Subject: Musik Express Aluminum Track

SERVICE BULLETIN

S.B. Number: 2001-02

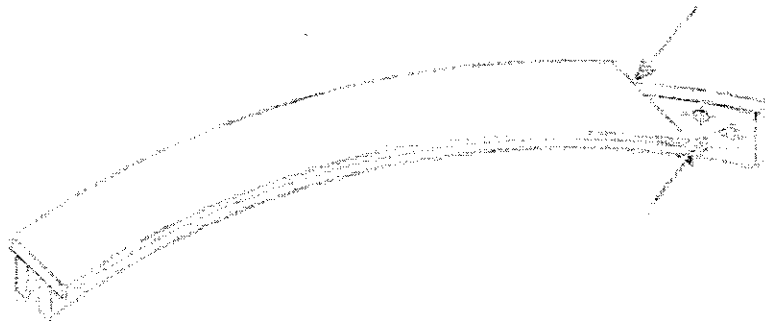
It has come to our attention that cracks have developed on the aluminum track where one track is bolted to the other.

The owner/operator must inspect the area around the singe bar (see diagram). If cracks are visible, they **MUST** be re-welded.
